# Access Compliance Report

## Public Rights-of-Way

### (Curb Ramps)

Intersection ID: 48999	Main Street: STEELECROFT_FARM_LN	Cross Street: STEELECROFT_PY	Location: NW
ADA ID: 2D76D4C09085	Ramp Type: Perp	Initial Pass/Fail: Fail	Overall Compliance: No
Severity Score: 1.25			
Codes/Mitigation Info/Possible Solution		Field Measurements/Component Compliance

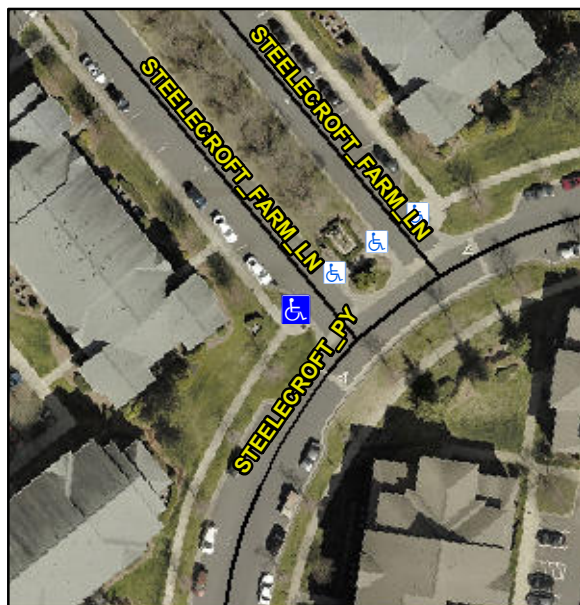
**Not Found, R304.5.3**

Compliance	Description	Data	Compliance	Description	Data
N/A	Ramp Length (in)	96.0	Yes	Ramp Slope (%)	6.2
Yes	Ramp Width (in)	50.0	No	Ramp XSlope (%)	2.6
N/A	Flare Type LT	N/A	N/A	Flare Type RT	N/A
N/A	Flare Slope LT (%)	N/A	N/A	Flare Slope RT (%)	N/A
N/A	Flare Traversable LT?	N/A	N/A	Flare Traversable RT?	N/A
N/A	Landing Length (in)	N/A	N/A	DWS Provided?	N/A
N/A	Landing Width (in)	N/A	N/A	DWS Contrast?	N/A
N/A	Landing Slope (%)	N/A	N/A	DWS Length (in)	N/A
N/A	Landing X Slope (%)	N/A	N/A	DWS Full Width?	N/A
N/A	Landing Curb? (Y/N)	N/A	N/A	DWS Offset (in)	N/A
N/A	Shared Landing?	N/A			
N/A	Gutter Ponding?	N/A	N/A	Gutter Slope (%)	N/A
N/A	Gutter Lip Ht (in)	N/A	N/A	Gutter X Slope (%)	N/A
N/A	Painted X Walk1?	No	N/A	Painted X Walk2?	N/A
	X Walk 1 Direction	To NE		X Walk 2 Direction	N/A
N/A	X Walk 1 Width (in)	N/A	N/A	X Walk 2 Width (in)	N/A
	X Walk 1 Slope (%)	0.6		X Walk 2 Slope (%)	N/A
	X Walk 1 X Slope (%)	1.4		X Walk 2 X Slope (%)	N/A

**Remove & Replace Entire Ramp.**
